**ADDENDUM NO. 1**  
**RFB # 12-020**

CONSTRUCTION DOCUMENTS FOR THE CONSTRUCTION OF THE  
12" WATER LINE FROM ELEVATED TANK NO. 7 TO SPARTAN TRAIL DR.  
RFB No. 12-020

THE WOODLANDS, TEXAS  
12" WATER LINE FROM ELEVATED TANK NO. 7 TO SPARTAN TRAIL DRIVE

P&P - STA. 8+50 TO 11+30

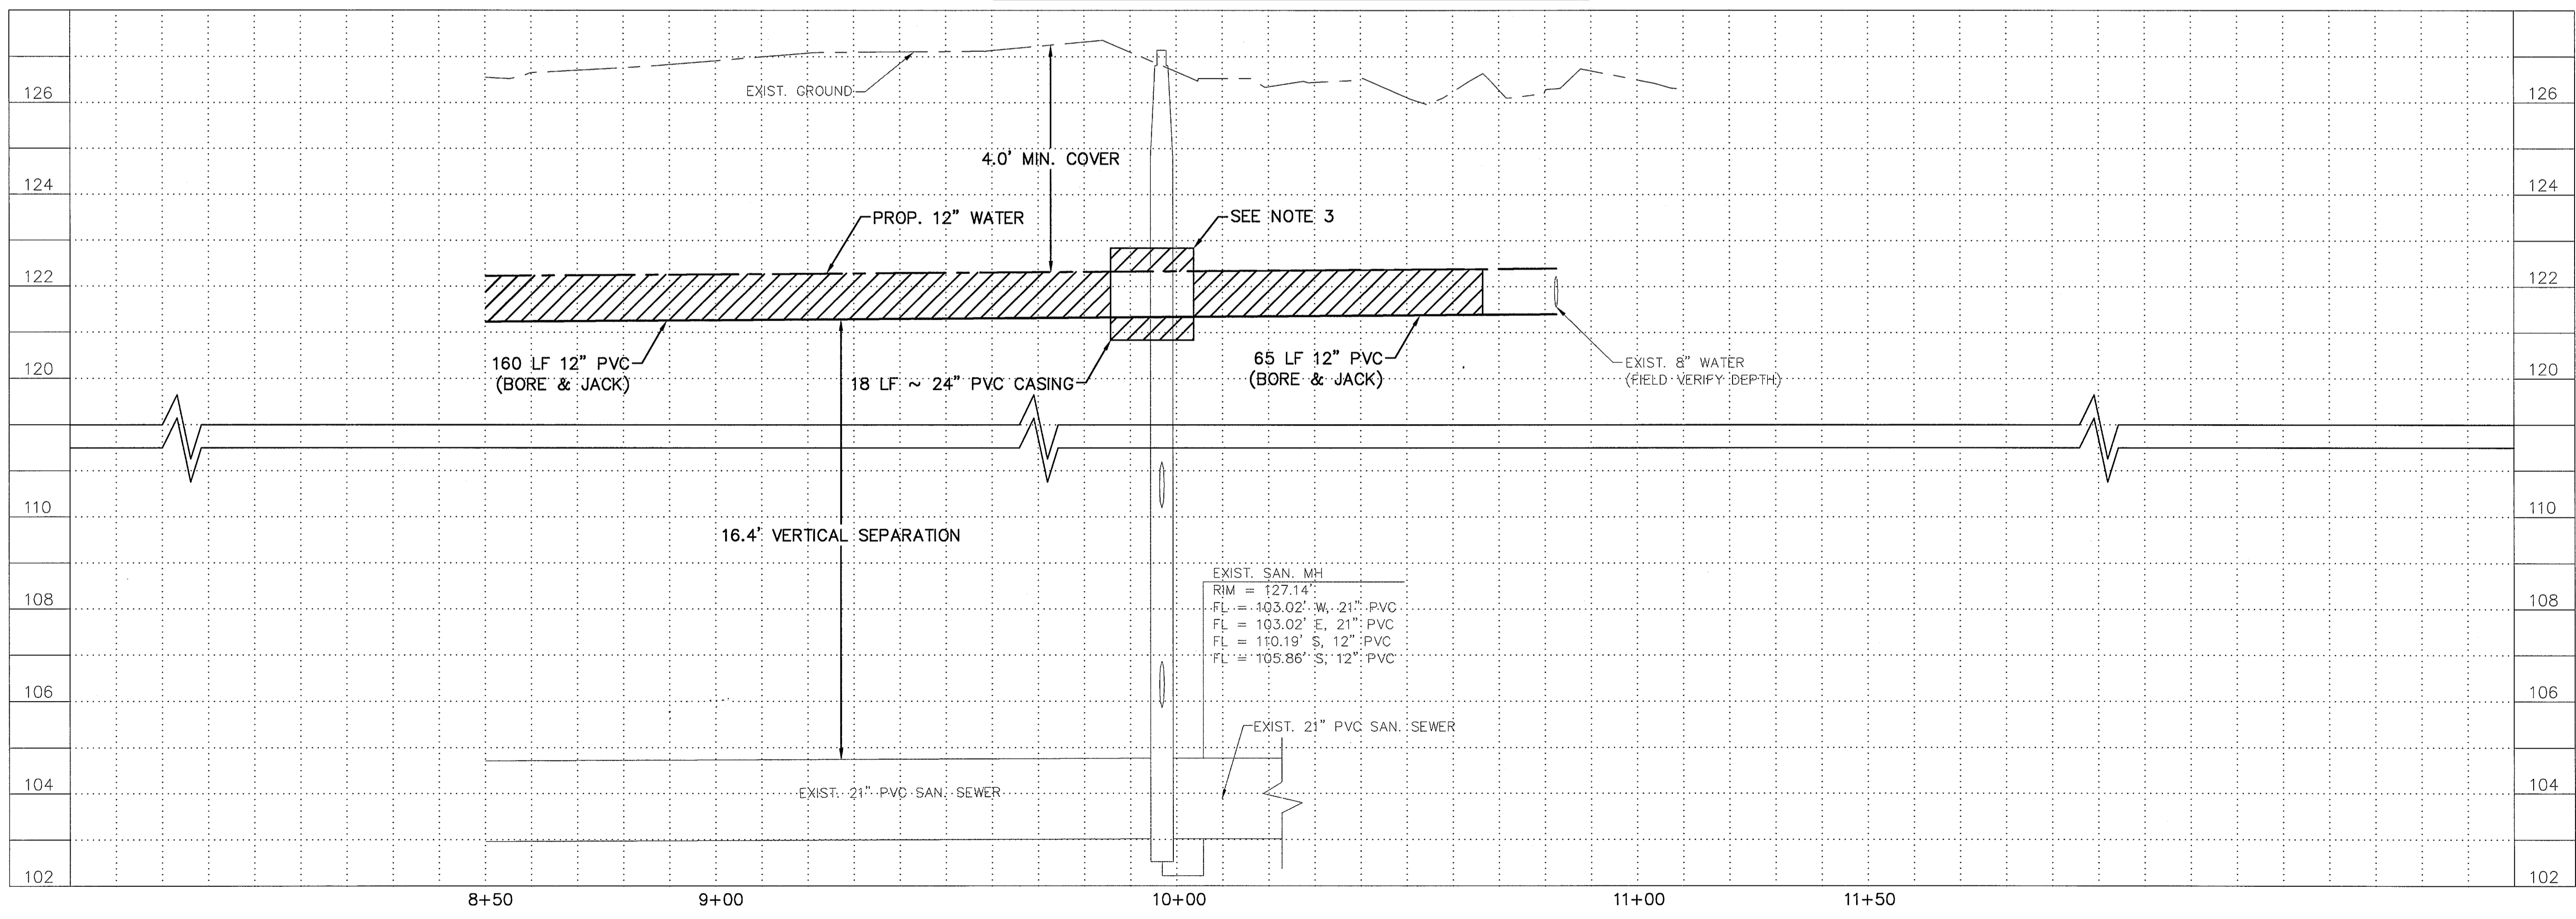
- Sheet 6: The proposed 12-inch water line connection into the existing 8-inch water line at Spartan Trail Drive has been modified. We will now be reducing the 12-inch water line to an 8-inch water line and use a tapping sleeve and valve to tie-in to the existing 8-inch water line. A revised sheet is attached.

No.	DATE	REVISION
1	11/09/11	MODIFIED WATER LINE CONNECTION
